Symptom In Vehicle Interior - Warning Message "TPM Fault Service Necessary" Appears In The Instrument Cluster: Re-programming control unit for Tire Pressure Monitoring (TPM) (SY 90/18)

Vehicle Type: **Panamera (971)**
Cayenne (9YA)

Subject: **Control unit for Tire Pressure Monitoring (TPM)**

TPM warning message

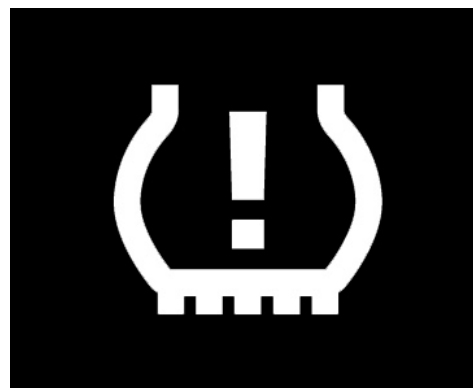
Symptom: The warning message "TPM fault Service necessary" may appear in the instrument cluster.
⇒ *TPM warning message*

Cause: The warning message can appear unnecessarily in the instrument cluster due to defective control unit software.

Remedial Action: In the event of a **customer complaint and if the software version in the control unit for Tire Pressure Monitoring (TPM) is "0630"**, re-program and code the control unit for Tire Pressure Monitoring (TPM) as described below.
